MAINE TURNPIKE AUTHORITY

ADDENDUM NO. 1

CONTRACT 2019.10

BRIDGE REPLACEMENT  
WARREN AVENUE OVERPASS (MILE 49.0)

SHEET NUMBER: 92  
 92 OF 141

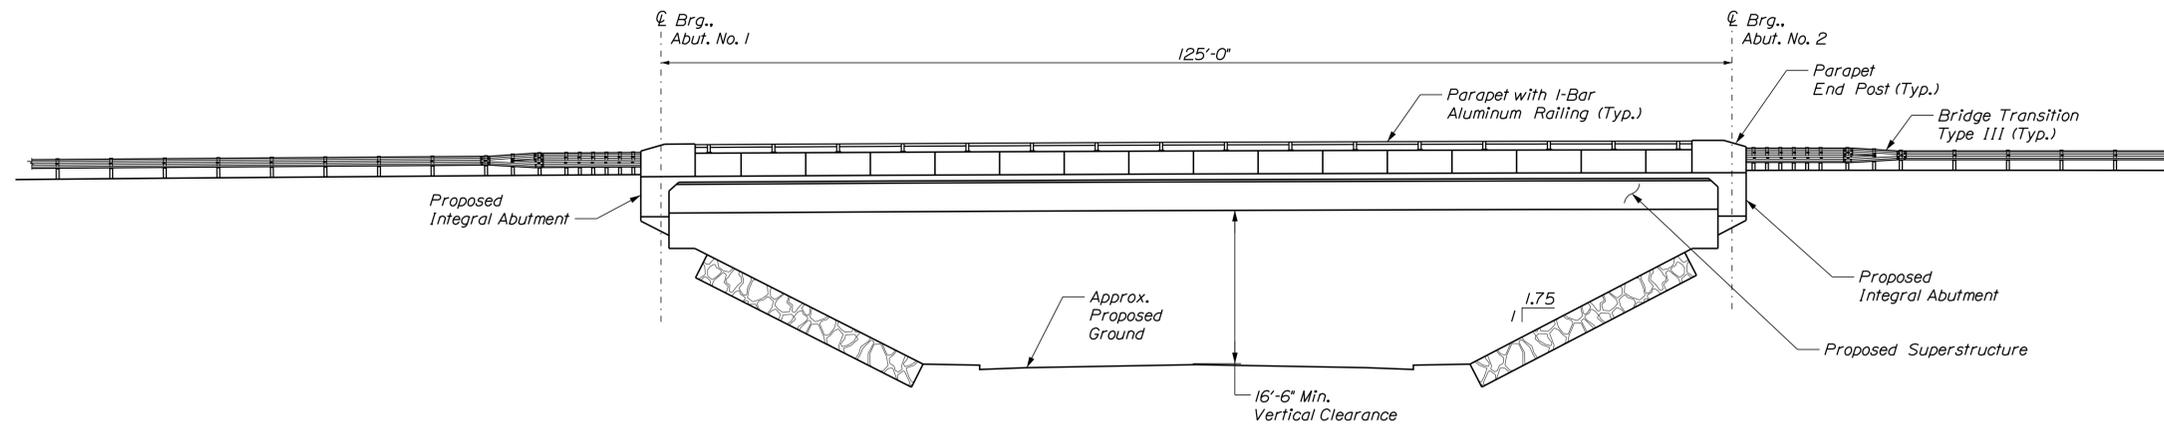
**Question 1:** Drawings note steel to be ASTM A709, Grade 50W which is weathering steel yet all steel shall be either metalized (girders) or galvanized (cross frames). Is this a typo or is this actually a requirement of the project?

**Response:** *Structural steel that shall be metalized or galvanized is not required to be weathering steel. See revised Contract Plan Sheet 92 which has been revised to reflect this response.*
